Bulletin

MODEL: BENTLEY MARK VI

FOR INFORMATION:FRONT SHOCK DAMPER SETTINGS.Increased Bump Load.

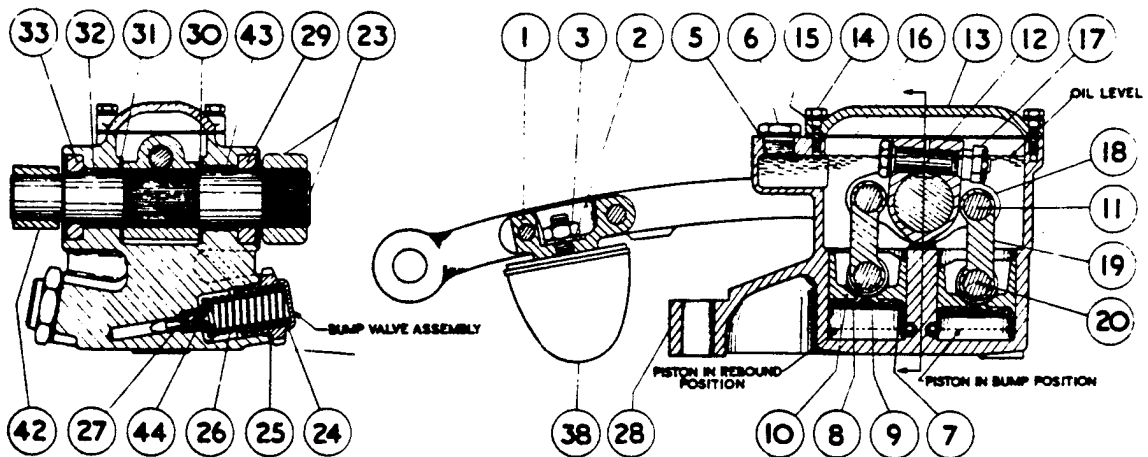
This Bulletin describes the procedure for raising the loading of the bump valve by replacing the existing bump valve spring with a new spring of increased strength, raising the bump loadings to 95-105 lbs., the rebound loading remaining unaffected. The part number of the spring giving the 95-105 lbs. bump loading is RF.5022, these are obtainable from Hythe Road Service Depot.

It is important to note that the bump valve cap of the L.H. damper is at the FRONT of the damper casing, whereas on the R.H. damper, the bump valve cap is at the REAR. In each case, the rebound valve cap is on the opposite side of the casing.

4. Remove the bump valve cap (24), aluminium washer (25) bump valve spring (26), bump valve (27), also any packing washers which may be fitted between the spring and the cap.

Clean the parts and replace in the damper using a new bump valve spring in place of the old one which was removed, also remove any packing washers, but do not tighten the valve cap.

FIG. 4. FRONT SUSPENSION SPRING IN POSITION - LATER MODEL CARS.

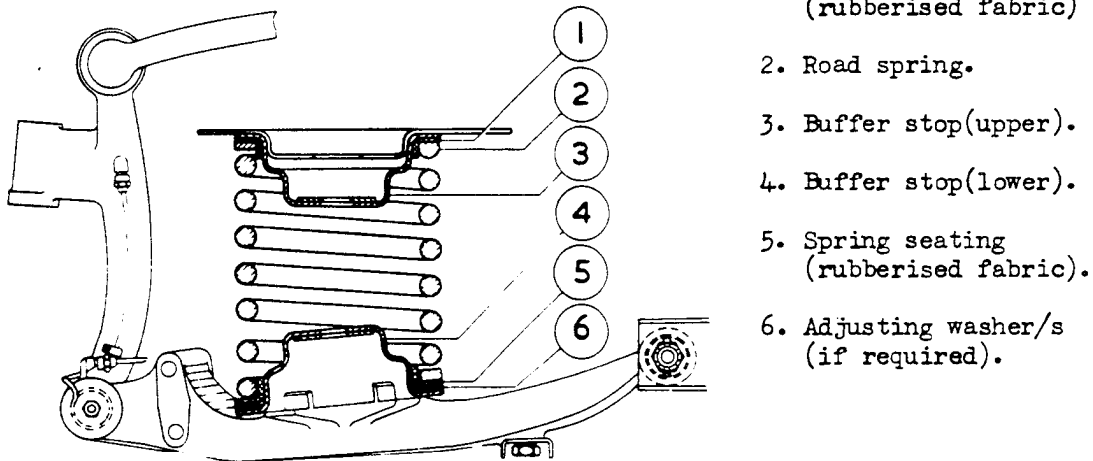
NOTE: On later cars, commencing at Chassis Nos. B-466-EY & B-126-LEY on which "Progressive Bump Stops" have been incorporated, the buffer housing, 4 Fig.3 and the rubber buffer (5) have been eliminated (See Fig.4).

FIG. 5. MODIFICATION TO SPRING COMPRESSING TOOL.

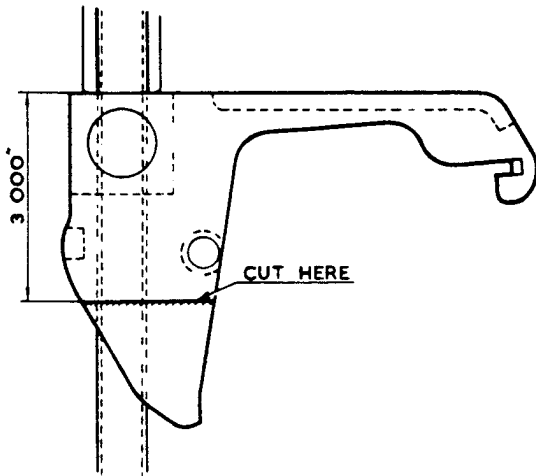
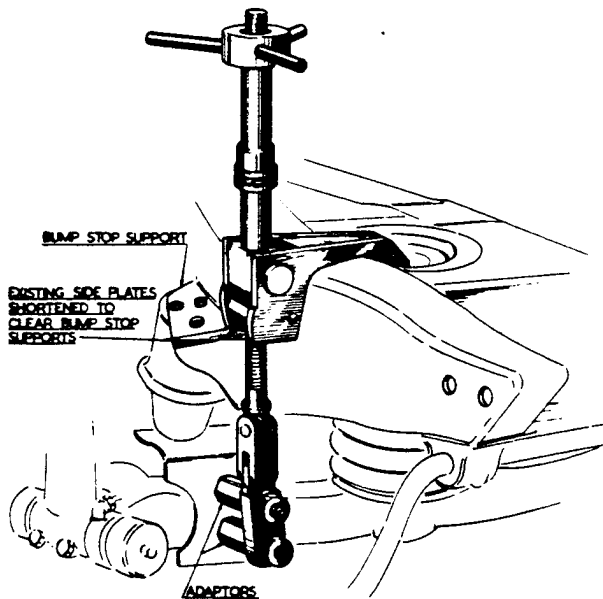
3. TO MODIFY AN EARLY TYPE FRONT SPRING COMPRESSING TOOL NO.3752/T1008:

In order to make the early type front spring compressing tool suitable for all types of chassis, the side plates of the clamp should be shortened to the dimension shown in Fig.5. A modified tool in this respect is shown in position in Fig.6. The later type production of this tool has shortened side plates.

On certain chassis it may be necessary to screw two adaptors (extension pieces) on to the two 1/2" (B.S.F.) studs at the front of the torque arm in order that a straight pull can be obtained with the tool when compressing a spring. These adaptors are shown in position in Fig.6. They are not supplied but can be made in accordance with details given in Fig.7.

FIG. 3.

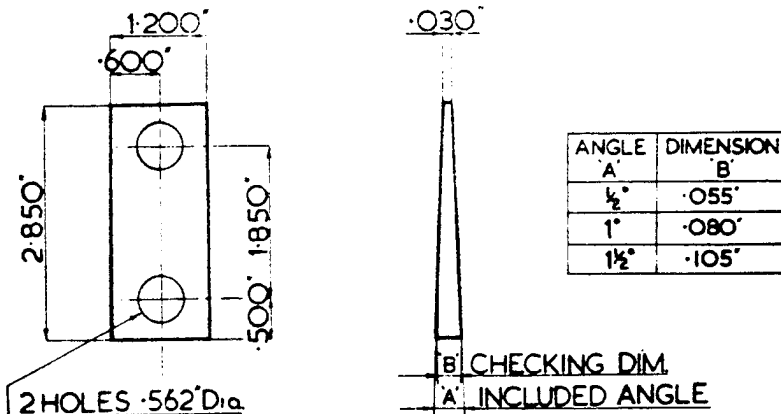
where castor angle is changed in a positive direction, it is possible that longer studs KB.963/Z-Torque arm will be required. A drawing of the taper packings required is given herewith (Fig.3) in order that they may be made up as required. The maximum change recommended is 1 1/2°.

MATL: LOW CARBON STEEL

FIG. 1.

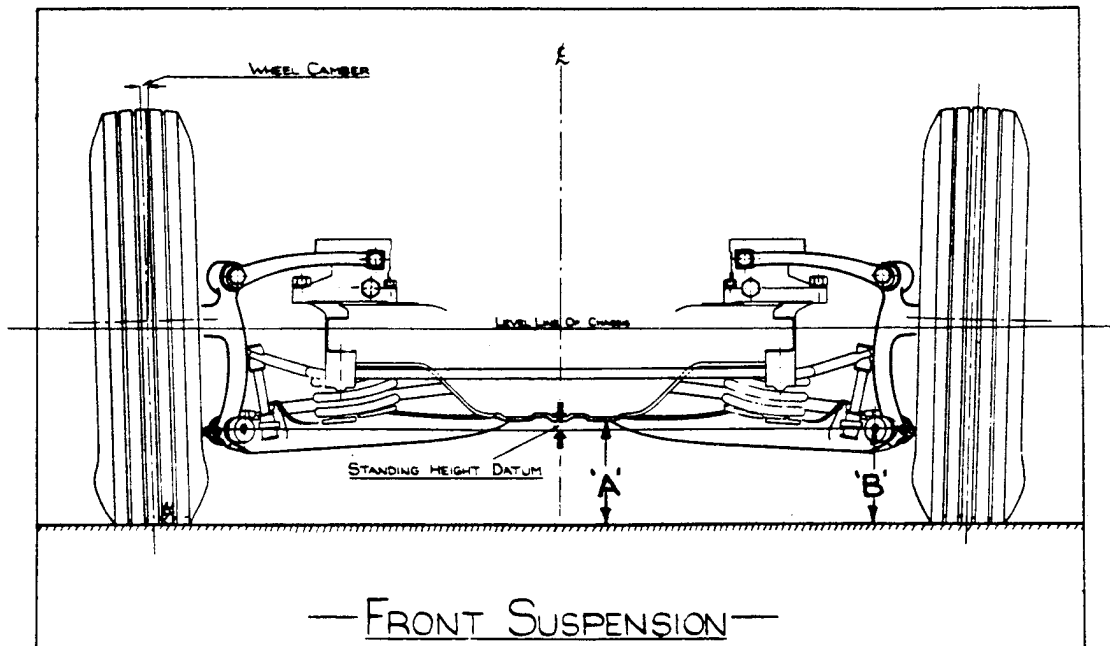
In consequence of the changes in the geometry of the radius arms mentioned above, the datum for measuring the standing height has been shifted relative to the ground as compared with the original design, and although the frame is .400" (10 m/m) higher than formerly, the reduced angularity of the lower radius arms means that the measurement of standing height can now become a negative figure.

A negative reading is when dimension 'B' Fig.1 is greater than dimension 'A'
A positive reading is when dimension 'A' is greater than dimension 'B'.

The limits for standing height are:- (car unladen).

(a) Standard Springs

.400" (10 m/m) negative
to
.200" (5m/m) positive

(b) Colonial Springs

.600" (15 m/m) positive
to
1.200" (30 m/m) positive

FIG. 2.

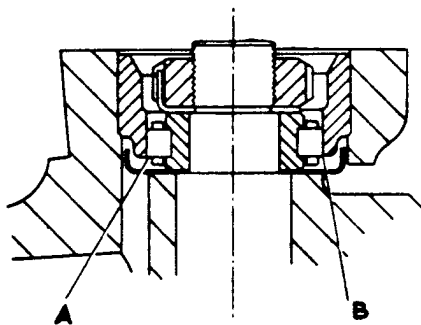
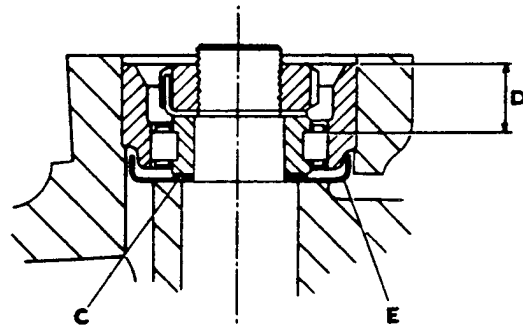
- (iii) Place a small straight-edge across the top face of the outer race of the upper roller bearing assembly of the pivot pin (not across the top face of the stub axle). With the rule of a small depth gauge, measure the distance downwards from the top face of the outer race to the top face of one of the rollers (not the brass roller cage), i.e. dimension 'D' Fig. 2 and note.

- a) If dimension 'D' is within the limits of .430" - .480" (10.9 - 12.2 m/m), this is correct.
 - b) If dimension 'D' is between the limits of .480" - .515" (12.2-13 m/m), then it will be necessary to remove the pivot pin and fit a .040" (1 m/m) thick packing washer ('C' Fig.2), Part No.R-4468, between the oil trough ('E') and the inner roller race.

- c) If dimension 'D' is over .515" (13 m/m), fit two packing washers.
- (iv) Having refitted the pivot pin and fully tightened the nut, check that the stub axle can be moved freely from one full lock to another, apart from the normal drag caused by the felt washer at the lower end of the yoke.

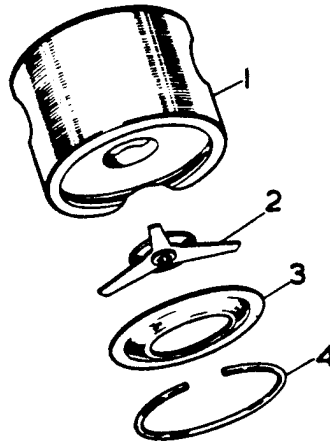
With the introduction of the revised steering geometry from chassis number B.1.GT onwards, a packing piece was fitted between the cross steering lever and the flange on the stub axle assembly to which the cross steering lever is bolted. It has been found that this packing piece is not essential and it has been deleted on production from chassis number B.89.PU onwards. In consequence shorter bolts, part number FB.4991, are fitted in place of the bolts RF.8198, and are the only bolts now available as replacements.

Should it at any time be necessary to replace the cross steering lever bolts, the shorter bolts, FB.4991, should be fitted and the packing piece discarded.
